Hawg Halters, Inc.
 389 Lumpkin County Parkway
 Dahlonega, GA 30533

PART NO.	HSCH-002		
PART:	SWITCH HARNESS, 2007-UP HD		
ASSEMBLY:	HAND CONTROLS		
SIZE	DWG. NO.	REV.	
A	105-103	F	
WEIGHT:		SHEET 1 OF 1

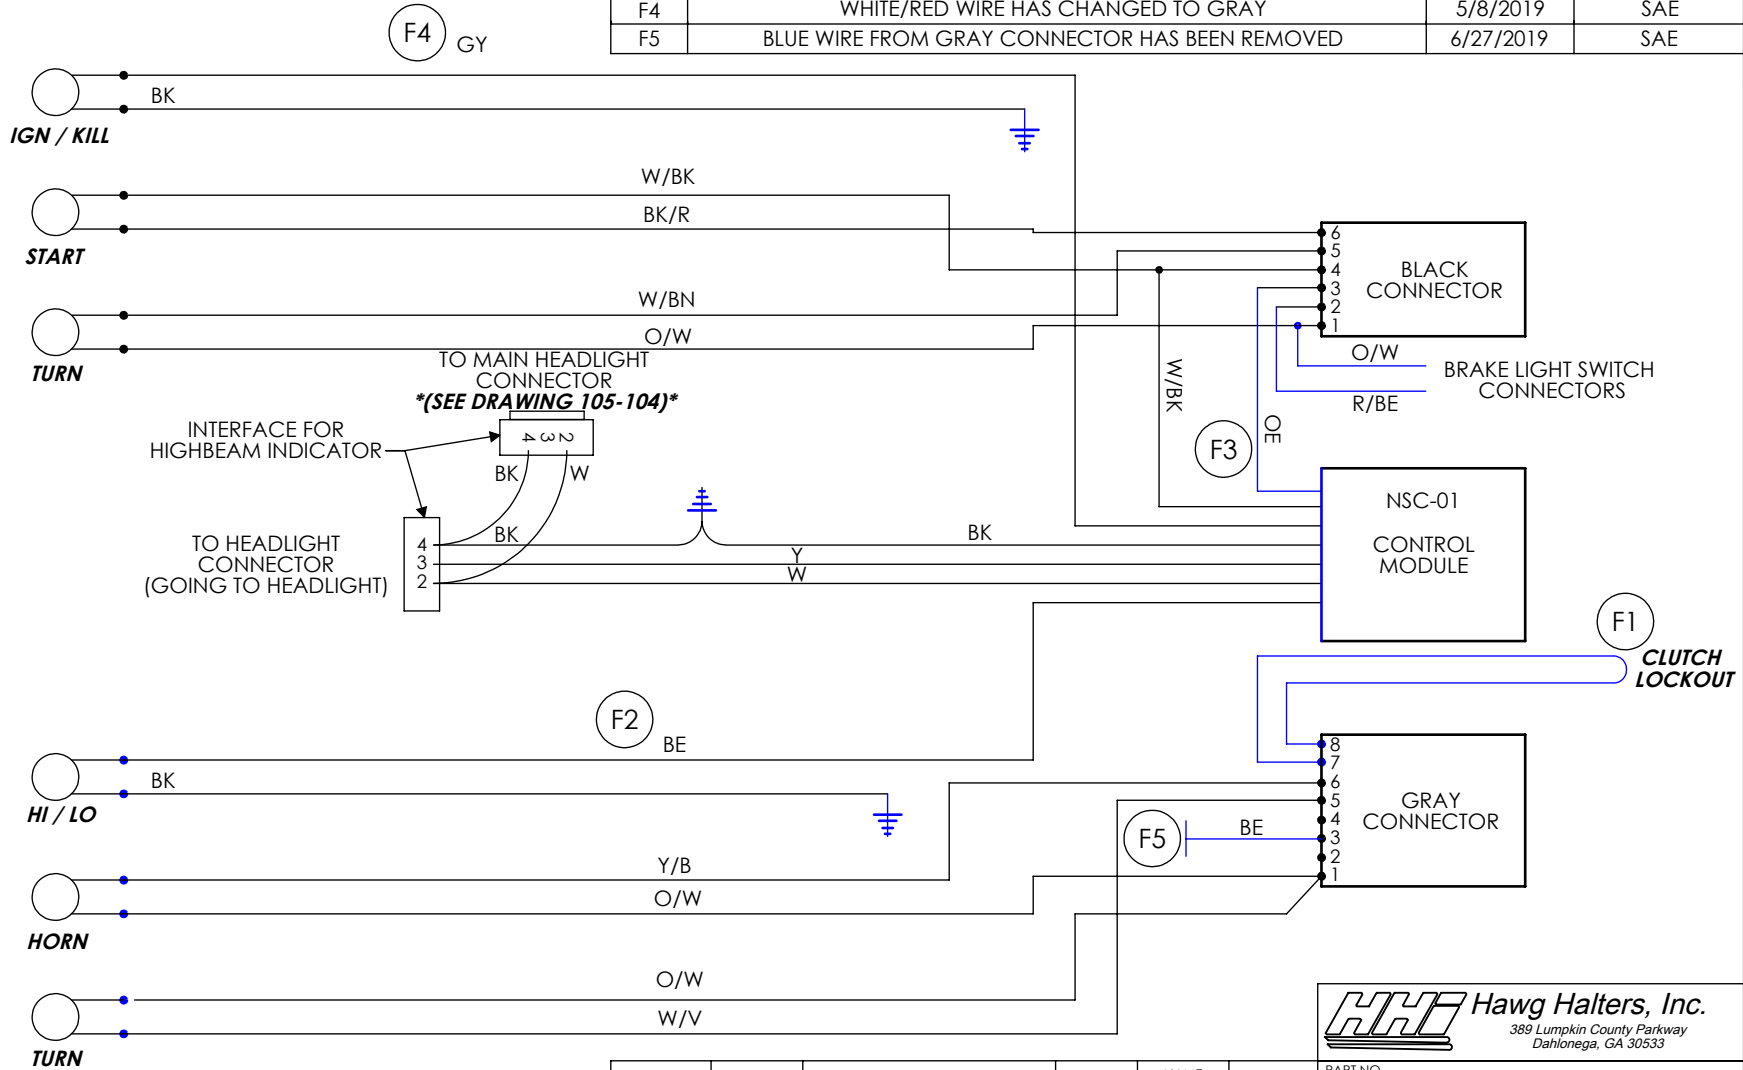
LTR	DESCRIPTION	DATE	APPROVAL
F1	ADDED CONNECTION FOR CLUTCH LOCKOUT	6/27/2019	SAE
F2	WHITE/YELLOW WIRE HAS CHANGED TO BLUE	6/27/2019	SAE
F3	GRAY WIRE HAS CHANGED TO ORANGE	6/27/2019	SAE
F4	WHITE/RED WIRE HAS CHANGED TO GRAY	5/8/2019	SAE
F5	BLUE WIRE FROM GRAY CONNECTOR HAS BEEN REMOVED	6/27/2019	SAE
